## CITY OF ALBUQUERQUE

Re: JW MMA Academy Apartments
301 Martin Luther King Ave NW
Traffic Circulation Layout
Engineer's/Architect's Stamp 09-14-18 (K14D005)

> CIRCULATION PLAN TRAFFIC LAYOUT

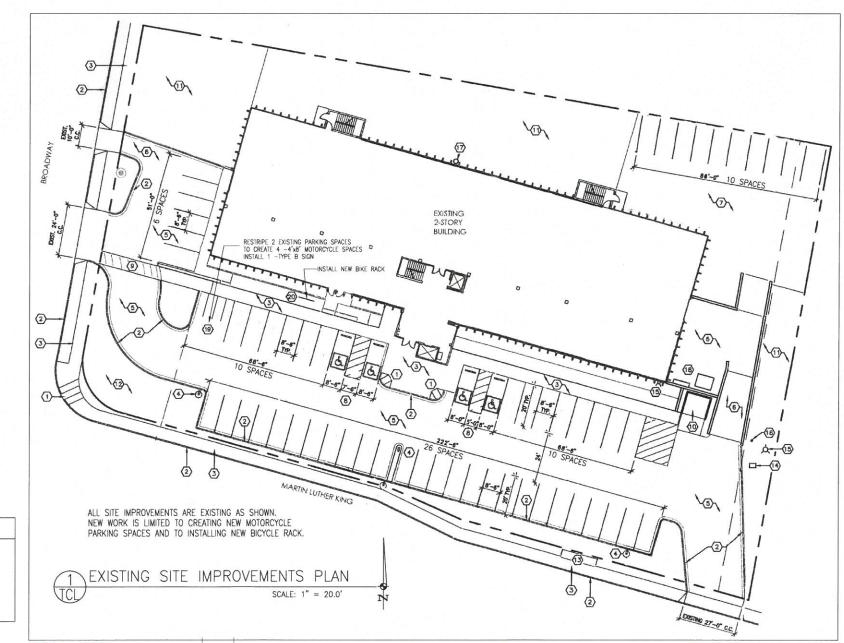
The TCL submittal received 09-14-17 is approved for Building Permit. A copy of the stamped and signed plan will be needed for each of the building permit plans. Please keep the original to be used for certification of the site for final C.O. for Transportation.
